# ADDENDUM

| DATE ISSUED | November 10, 2026 | ADDENDUM # | 2 |
| ENGINEER | Engineering Technologies, Inc.<br>1101 North 13th Street<br>Omaha, NE 68102 | PROJECT | IWCC Fremont Hall –<br>Electrical Service Replacement |

Job Desc: UG Extension - IWCC 402-850-8316

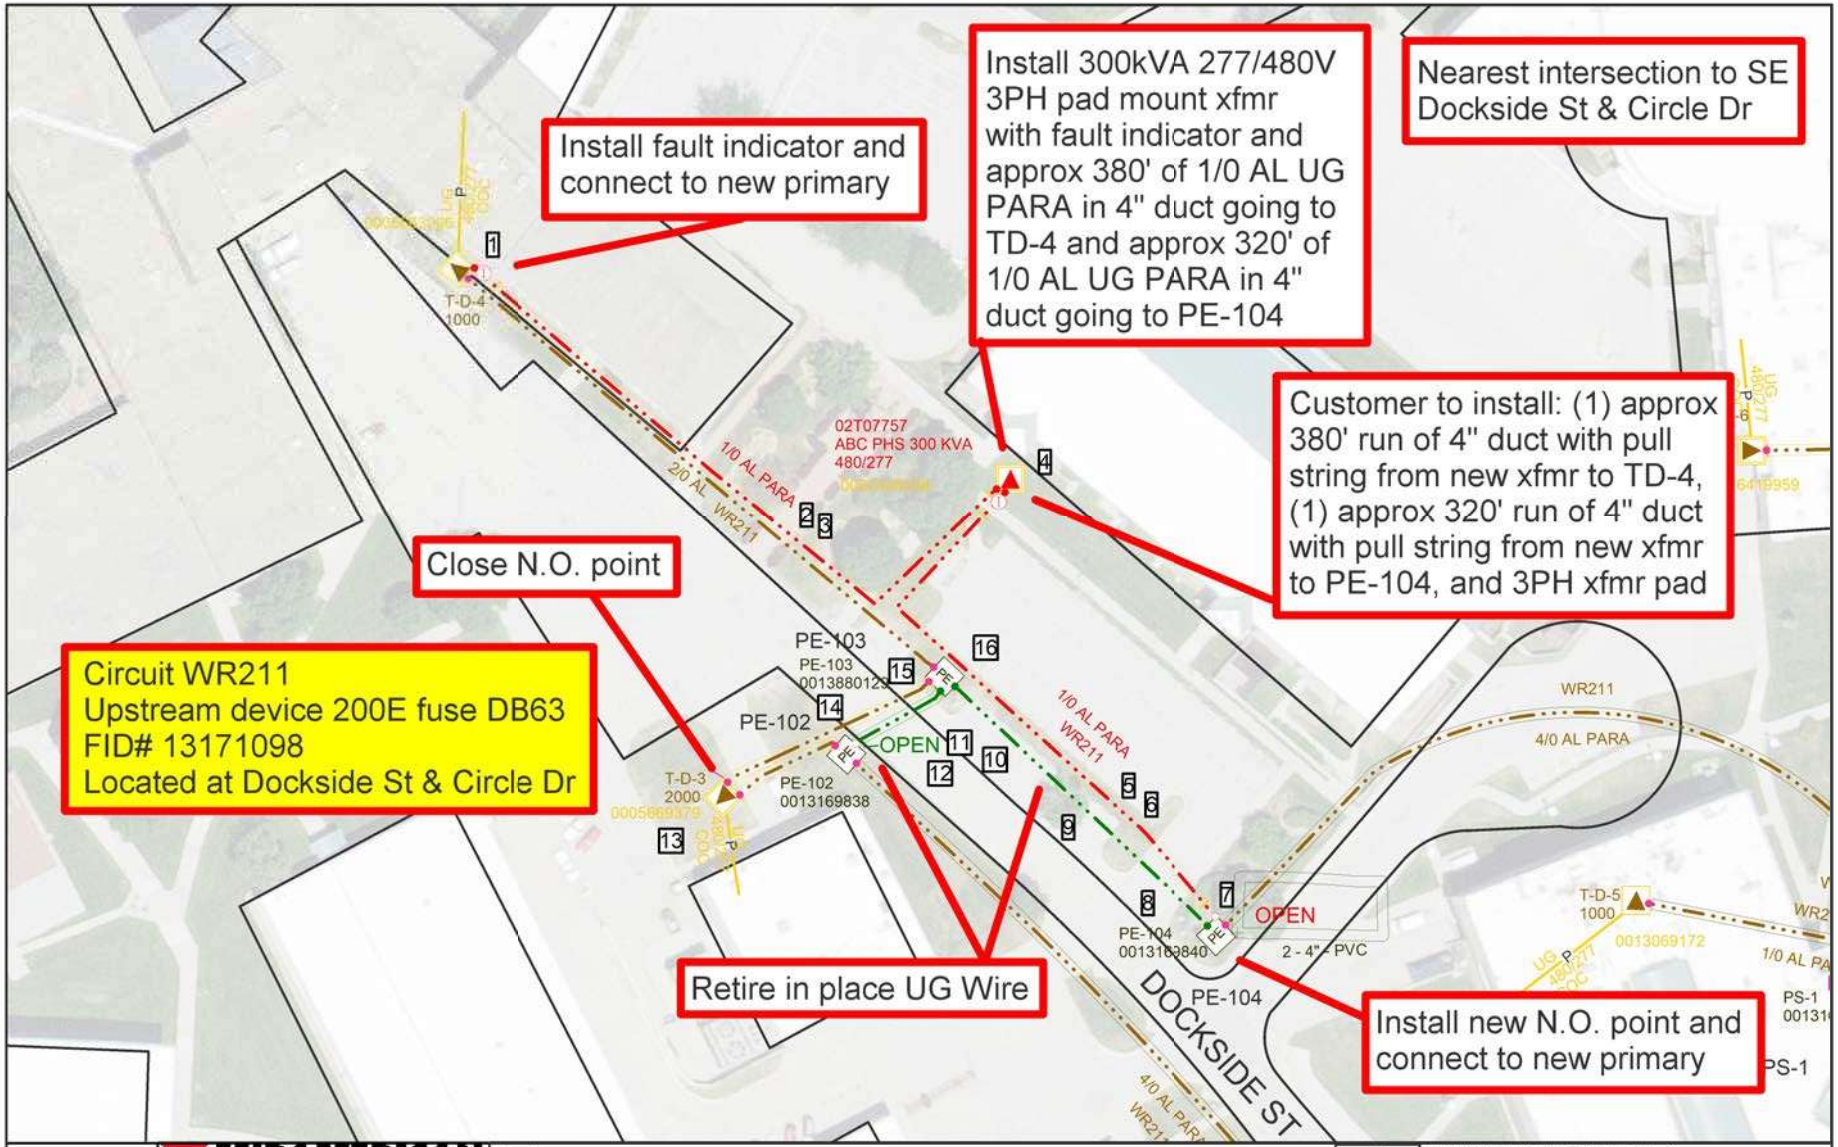
A. Looft and Lewis Hall Services
   i. See attached Mid-American Energy (MEC) design plans for each service.
   ii. MEC service costs are to be paid by the owner and not included in the bid.
   iii. IWCC had a locate completed for the areas affected by the new services for review prior to bidding. During construction the contractor is responsible for getting private and public locates completed prior to performing any work.
B. Schedule revisions
   i. See attached updated panel schedule PCB.
   ii. Hoover Panel P1 is clarified to be an existing 225A panel to be replaced at the same amperage size.
